NUCLEAR REGULATORY COMMISSION

Title: Advisory Committee on Reactor Safeguards
Fukushima and Reliability and PRA

Date: Tuesday, July 7, 2015

The SECY paper describes the staff's plans to make the requirements of the severe accident capable containment vent order, EA-13-109, generically applicable to Mark I and Mark II BWRs, and that the use of external water during a severe accident is a worthwhile benefit.

High-Level Conservative Estimate Calculation

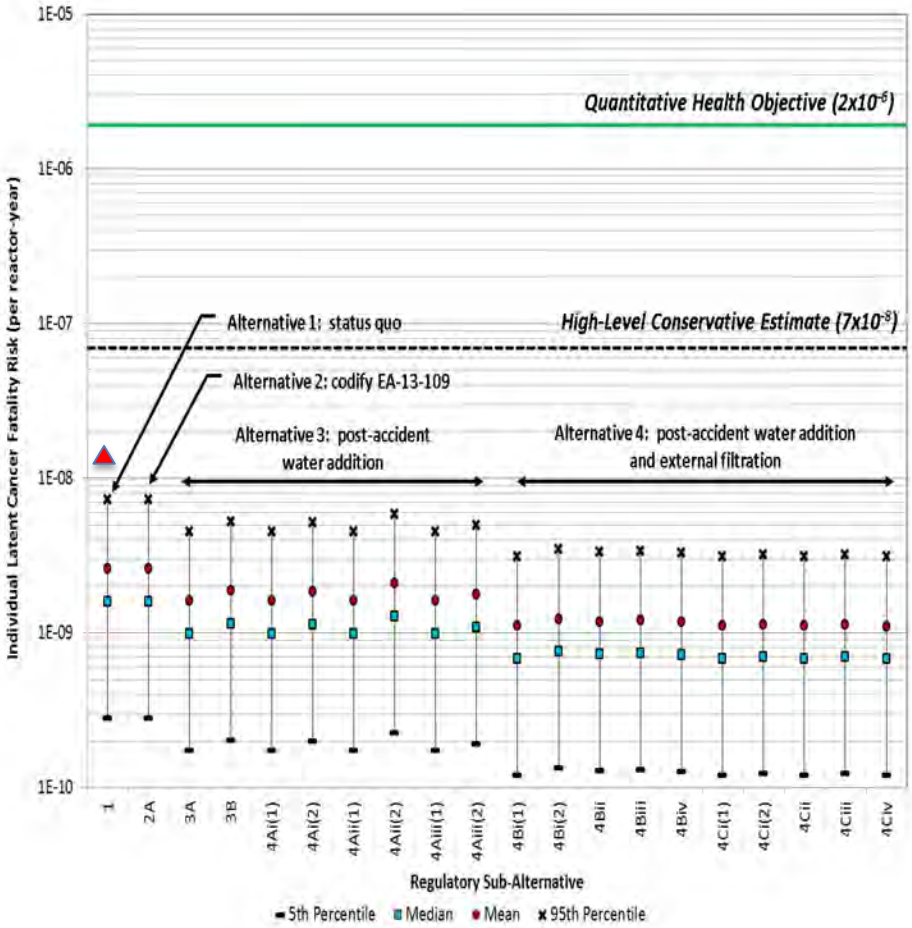
MEMBER STETKAR: I was just going to ask this, and this may be a Marty question too, but I kind of got confused when I saw this figure. I understand how the high level conservative estimate is, was quantified, okay. I understand that. This figure, I don't understand how all of the estimates with the uncertainty bounds relate to that thing.

I mean this figure forces me to compare the QHO, this high level estimate, and then all of that detail down in the bottom, and understand what they mean relative to one another. And I for one couldn't figure out how all the detail relates to the high level, what you're characterizing as the high level conservative estimate.

MEMBER STETKAR: Okay, okay. I actually understand where all the numbers come from. I just don't know how to interpret this particular figure. I understand how to interpret the figure without all of the noise in the bottom, and I understand how to interpret all of the noise on a stand-alone basis.

MEMBER STETKAR: In truth, I've thought a little bit about this. In truth, that affects a lot of the stuff that I was calling the noise on that filter, on that figure. It affects a lot of the stuff on the noise. It doesn't have a big --

If you look at that figure and take their high level conservative estimate and increase it by a factor of one and a half or so, so you make it 1E to the minus 7-ish roughly, it's still an order of magnitude more or less below the quantitative health objective.

MR. BEALL: So as it also -- as the chart also shows, the high level conservative estimate is more than an order of magnitude below the QHO, and it's also close to the COMSECY risk value for the expedited spent fuel transfer, which is the red triangle. Which is kind of going back to your question.

MR. ESMAILI: This is Esmaili. The red triangle was the highest, was the highest release and the highest consequence that we found for all the plants. This was not for Peach Bottom. This was --
